Addendum: Technical Guidelines for Minor Works
related to Window Works in Domestic Unit

3.23.1 Minor Works Related to Window Works in domestic unit

(i.e. Minor Works Items 1.6, 2.5 and 2.8)

SHEET 1 OF 3

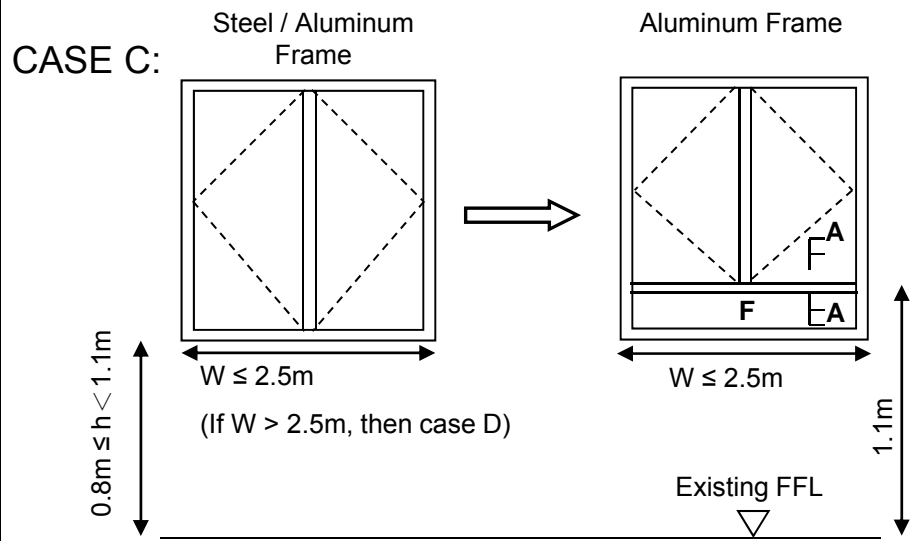
- Construction, alteration or repair of the window main frame in accordance with item 2.8 and all its requirement.

- MW items 2.5 and 2.8 for replacement of window main frame according to original design.

<p>MINOR WORKS ITEM RELATED TO WINDOW</p>	<p>CONSTRUCTION, ALTERATION OR REPAIR OF ANY WINDOW IN DOMESTIC UNIT ABOVE GROUND FLOOR (For window replacement works in which the original design is not available)</p>	<p>SHEET 2 OF 3</p>
--	---	----------------------------

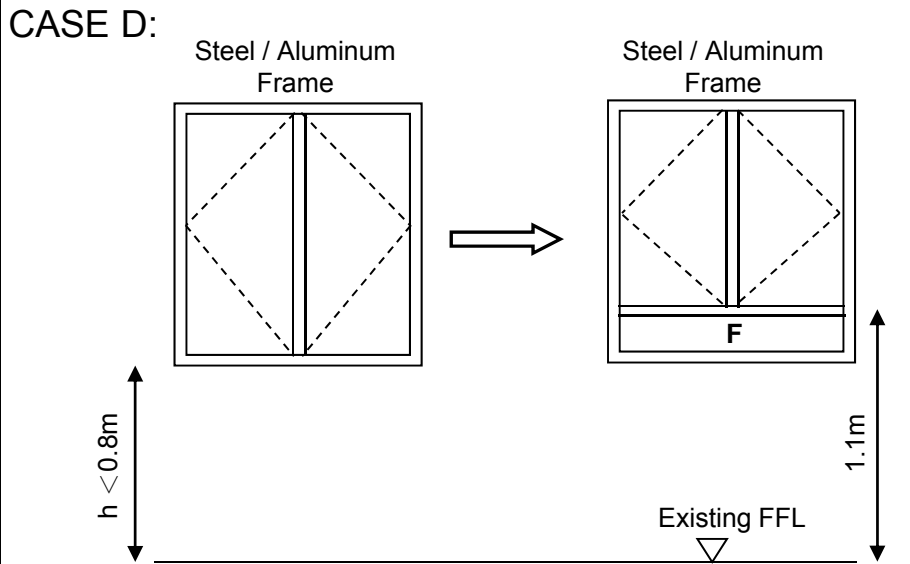
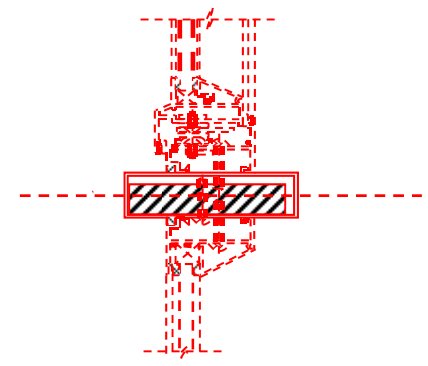
- MW Item 2.8 for replacement of window main frame and enhancement works (Refer to sheet 3 of 3 for details)

- MW Items 1.6 and 2.8

SHEET 3 OF 3

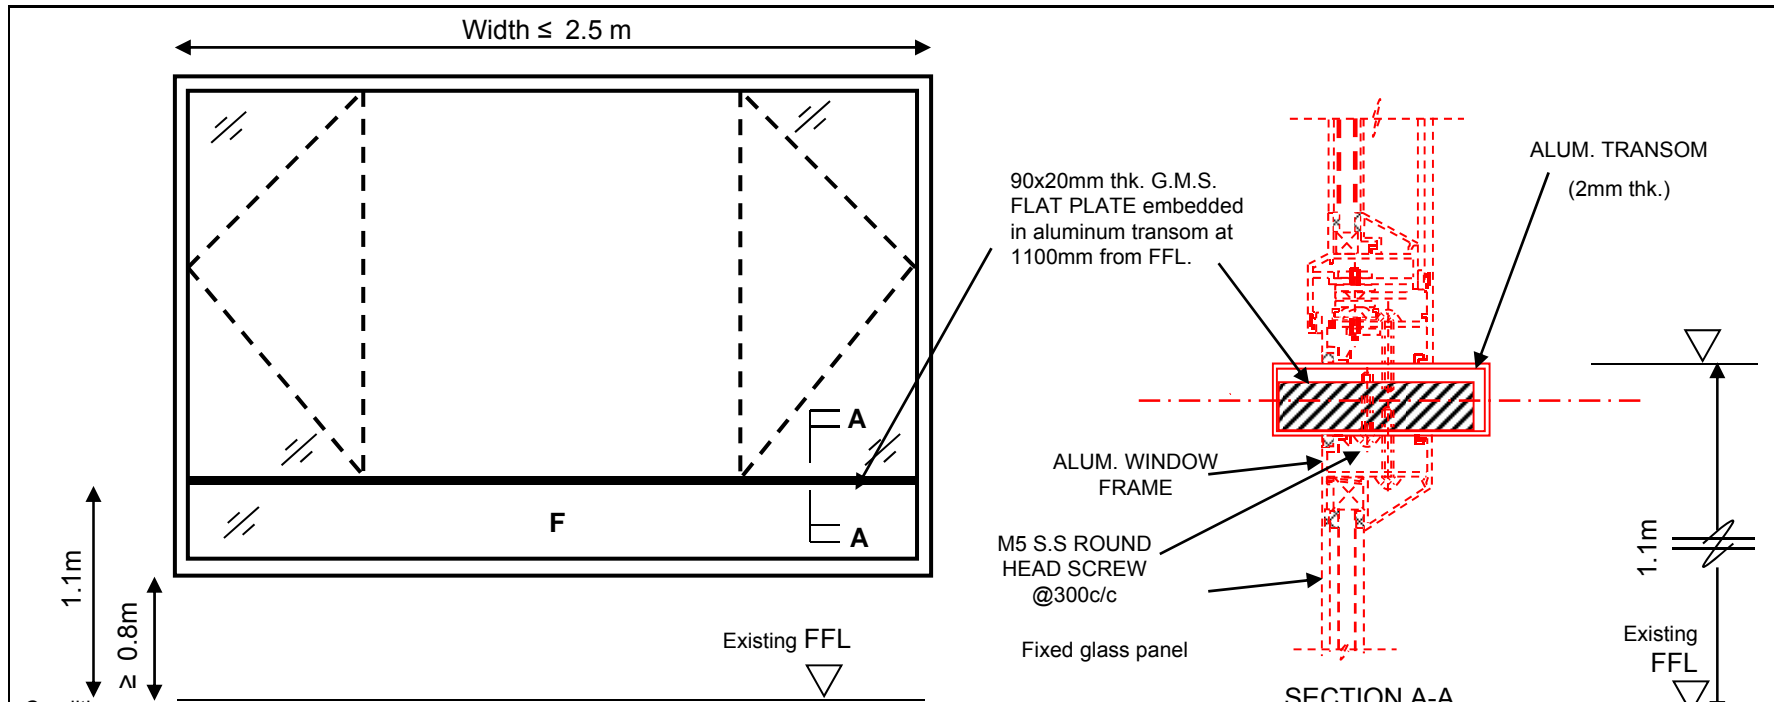
1. The distance between the highest point of the window or window wall and the ground is not more than 100m.
2. Wall opening should not be altered, and width of original wall opening should not be greater than 2500mm;
3. A 90x20mm thick G.M.S flat plate to be fixed inside the transom located at 1100mm from FFL by round head screws at spacing 300mm centre to centre, and extent to full length of opening width with both ends of flat plate rigidly fixed in place to main frame of window. Structural steel plates to be grade S275 to BS EN 10029 and shall be hot dip galvanized to BS EN ISO1461. (Record photos showing the embedded G.M.S. flat plate should be submitted together with Form MW04.)
4. Height of fixed glass panel below transom should not be greater than 300mm;&
5. Fixed glass panel to be safety tempered glass of minimum 6mm thick in accordance with APP-110.

1. All fixing lugs shall be of stainless steel or hot dip galvanized steel having a minimum material thickness of 1.5mm and be placed at 300mm centres maximum.
2. All structural members of a window section shall have a minimum aluminum thickness of 2mm and the depth of the mullion section shall not be less than 38mm.

3. 4-bar hinges shall be manufactured from stainless steel with adjustable friction shoe, and all stainless steel bars of the hinge shall have a minimum thickness of 2.5mm.

4. Stainless steel rivets/screws shall be used for the fixing of hinges.
5. At least 3 Nos. of 4.8mm diameter stainless steel rivets or 5mm diameter stainless steel screws shall be used to fix each bottom and top bars of the hinge to the window frame and the openable sash.

6. Due consideration and measures should be taken to prevent contact between dissimilar metals.
7. A secure mechanical fixing, for example by inserting a stainless steel or hot dip galvanized steel plate or bar/angle of not less than 3mm thick inside the section to provide sufficient threads for the screw(s) shall be adopted. As an alternative, the window sections for fixing the hinge may be thickened locally to not less than 5mm.

8. The length of the 4-bar hinge should be at least 60% of the width of the side hung casement window.
